## Department of Energy

### TRANSMITTAL OF PROPOSED CHANGES RESULTING FROM THE 1999 ANNUAL REVIEW OF THE INTEGRATED ENVIRONMENTAL MONITORING PLAN

## SUMMARY TABLE OF PROPOSED TECHNICAL CHANGES TO THE INTEGRATED ENVIRONMENTAL MONITORING PLAN, REV. 1

FIGURE A-1. DRAINAGE BASIN AREAS AND ASSOCIATED SURFACE WATER MONITORING LOCATIONS

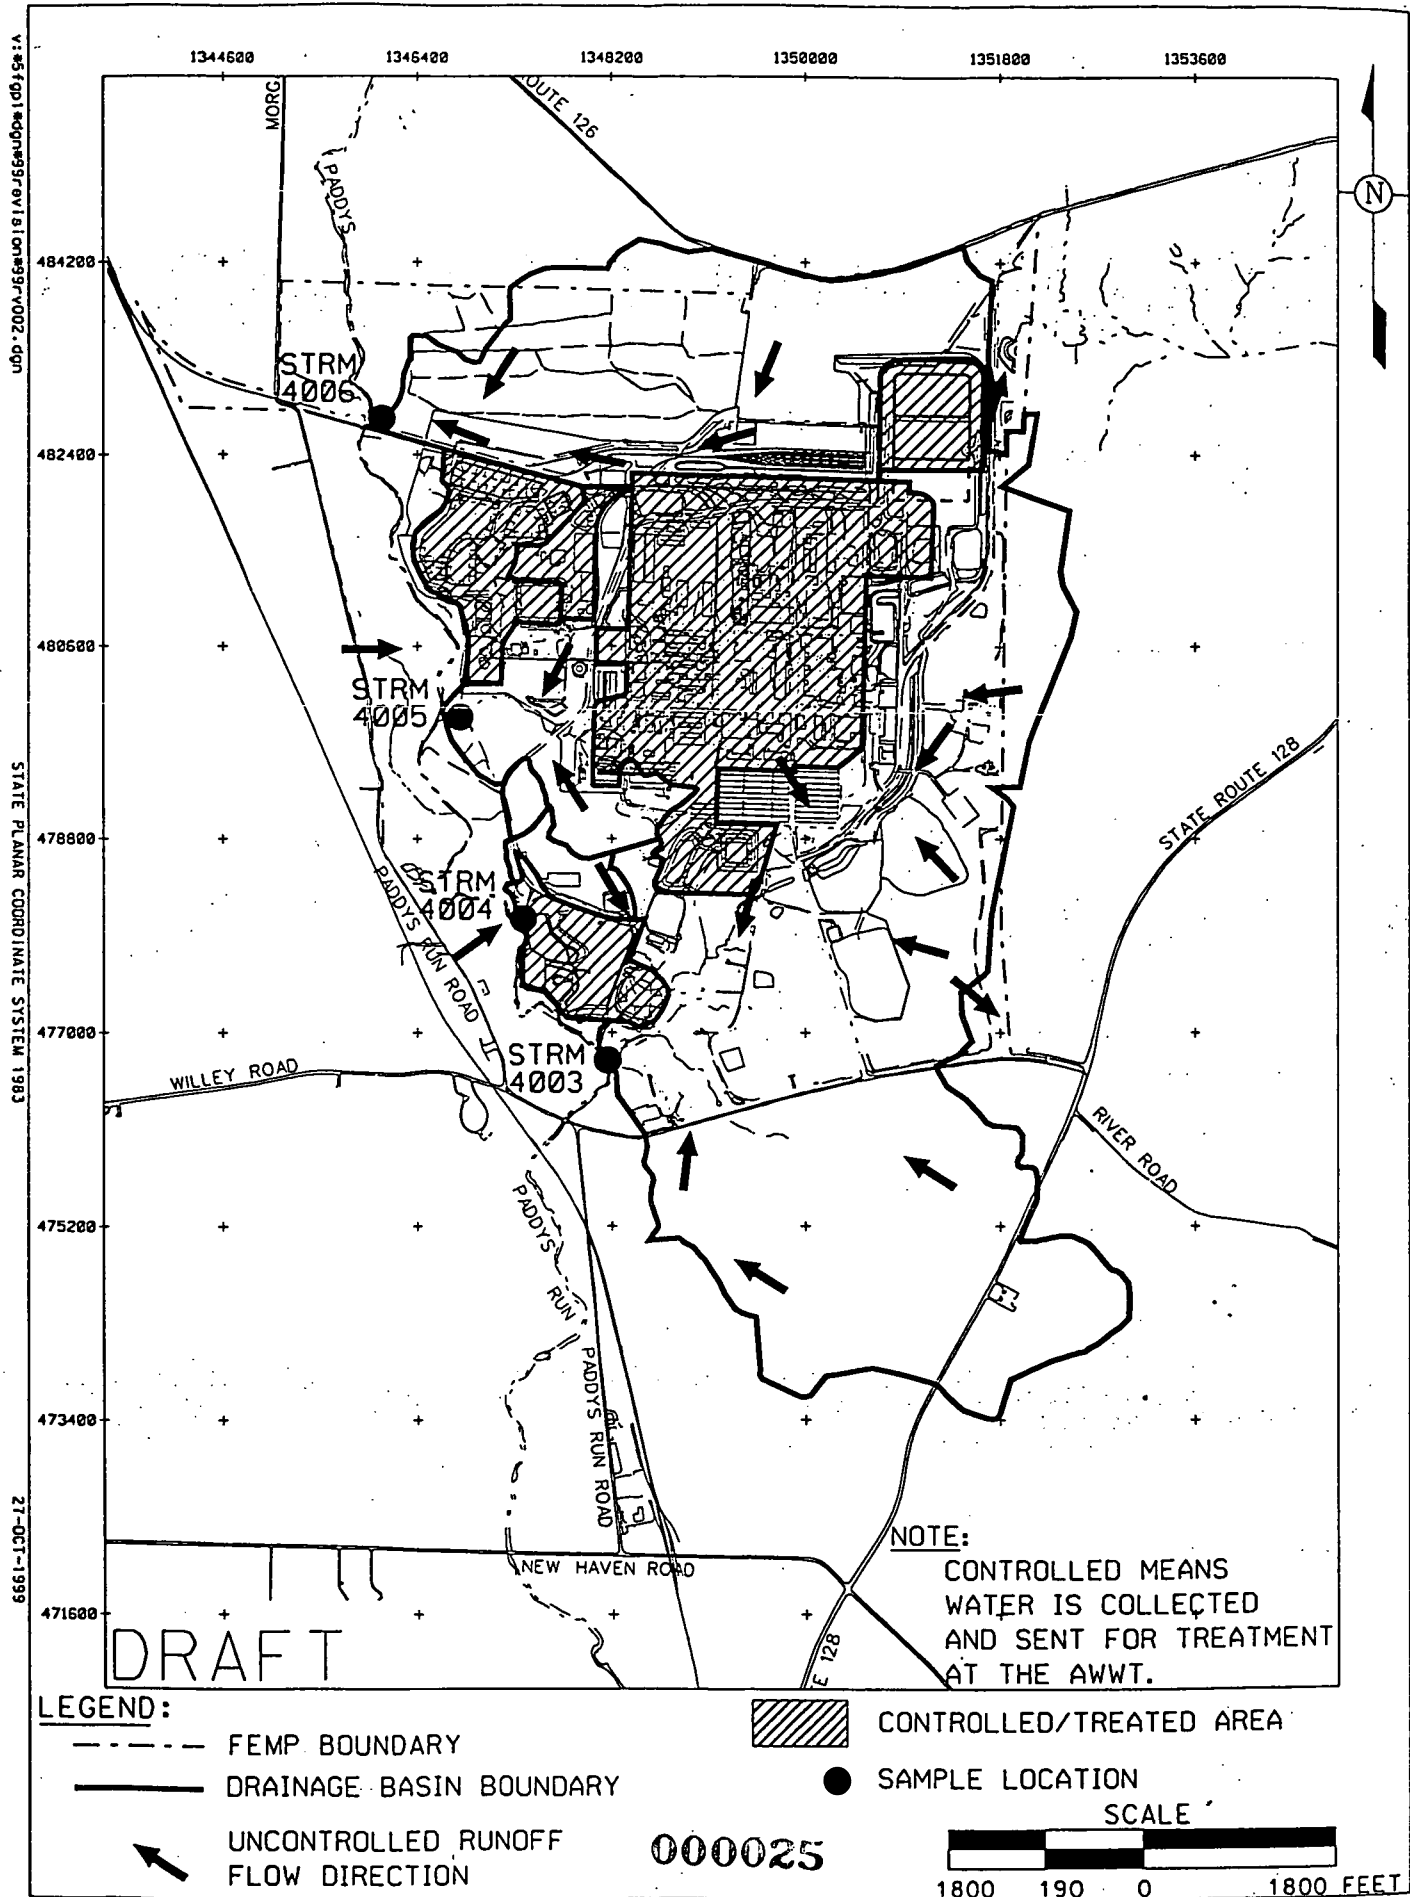
Therefore, the estimate of uranium discharged to the environment through uncontrolled runoff per inch of rainfall has been re-evaluated and documented in this review. The calculations to support the new estimate, based on more current drainage basin patterns and more recent analytical data collected at the discharge points into Paddys Run, are provided in Attachment 1. As expected, the revised estimate for the amount of uranium released through uncontrolled runoff is significantly less (2.53 pounds per inch of rainfall) as a result of the removal of contaminant sources and the additional measures that have been taken to control contaminated runoff over the last several years. Beginning in January 2000, the loading term of 2.53 pounds of total uranium per inch of rainfall will be used in calculations estimating the pounds of total uranium entering the environment through uncontrolled runoff.

The acres associated with the drainage basins (total, pervious, and impervious) are presented in Table A-2. Total drainage basin area acreage does not include any acreage where surface water is controlled (refer to Figure A-1). Therefore, because the amount of controlled areas has increased (e.g., areas in the vicinity of the on-site disposal cell and the southern waste units) since the remedial investigation, the total acreage associated with the drainage basins has been reduced. Pervious drainage basin area refers to those areas with natural surfaces (e.g., grass and soils) and impervious drainage basin area refers to those areas with manmade surfaces (e.g., paved roads, gravel roads, and structures with roofs).

The loading value of 2.53 pounds of uranium per inch of rainfall will be used in future calculations when estimating the pounds of uranium entering the environment through uncontrolled runoff. As expected, the revised estimate for the amount of uranium released through uncontrolled runoff is significantly less (2.53 versus 6.25 pounds per inch of rainfall) as a result of the removal of contaminant sources and the additional measures that have been taken to control contaminated runoff over the last several years. In an effort to maintain an accurate loading term, this evaluation process will be repeated in the future as remediation progresses and site conditions affecting the quantity and/or quality of uncontrolled runoff are observed.

FIGURE 6-3. RADON MONITORING - CONTINUOUS  
ALPHA SCINTILLATION LOCATIONS

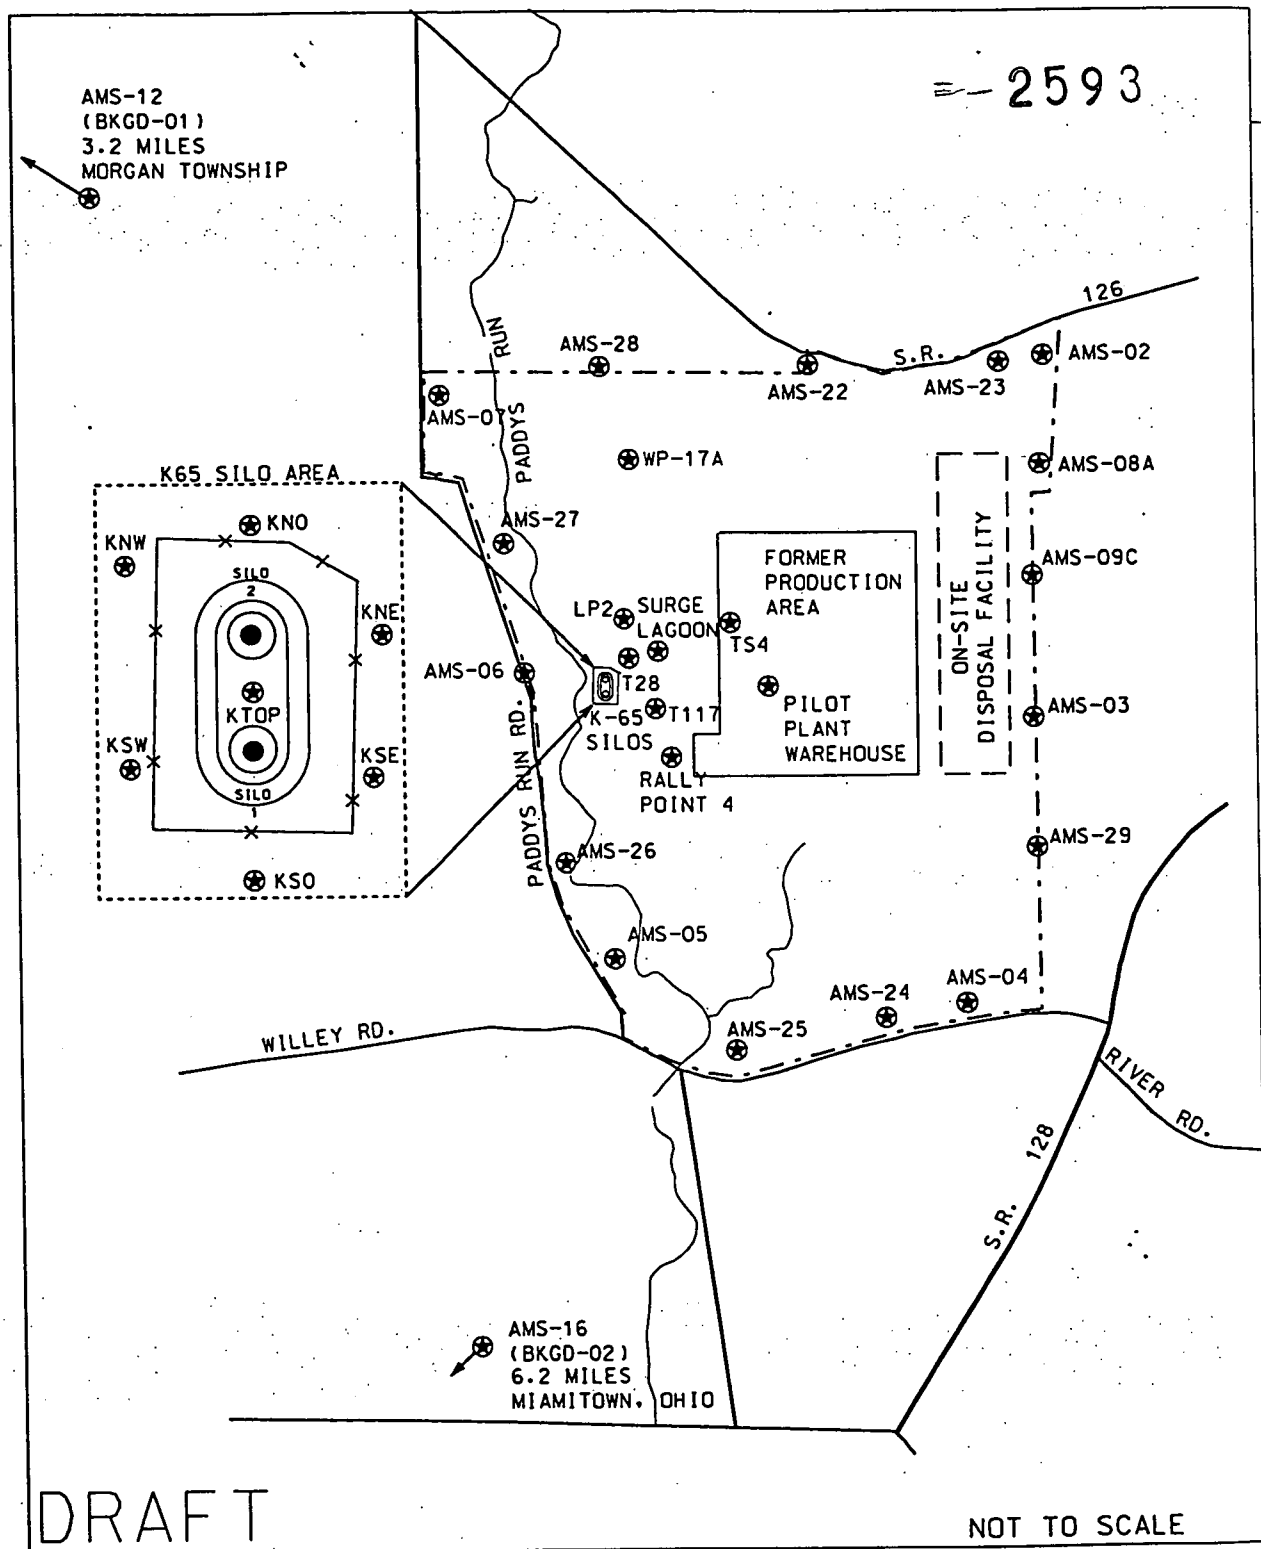
Finally, DOE is proposing to add four monitoring locations to the Radon Monitoring program in the area of the K-65 Silos, in preparation for the Silos 1 and 2 Accelerated Waste Retrieval Project, and subsequent treatment operations for the Silos 1, 2, and 3 materials (locations for these monitors are described in the Summary Table and Attachment 4).

Section/Page Number	Description of Proposed Modification	Driver/Technical Information
Figure 6-3, pg. 6-19	<p>It is proposed that four monitoring locations be added to the map (refer to Attachment 4). The tentative locations and designations for the monitors are:</p> <ul style="list-style-type: none"> <li>• North of Silo 2 at the K-65 exclusion fence, designated as KNO</li> <li>• South of Silo 1 at the new south camera tower, designated as KSO</li> <li>• To the east of Silo 4, midway between Silo 4 and the Bio-Surge Lagoon, and in the prevailing wind direction from Silo 3, designated as LP2</li> <li>• Southwest of the High Nitrate Storage Tank, near pole #543 at Trailer #117, designated as T117.</li> </ul> <p>The availability of electric power, as well as, construction activity in the Silos Project area may delay the installation or necessitate the relocation of the monitors from the tentative locations. The monitors are expected to be in operation by January 2000.</p>	The locations will provide additional monitoring of radon levels in the vicinity of the silos in preparation for the Silos 1 and 2 Accelerated Waste Retrieval Project and subsequent treatment operations for the Silos 1, 2, and 3 material.
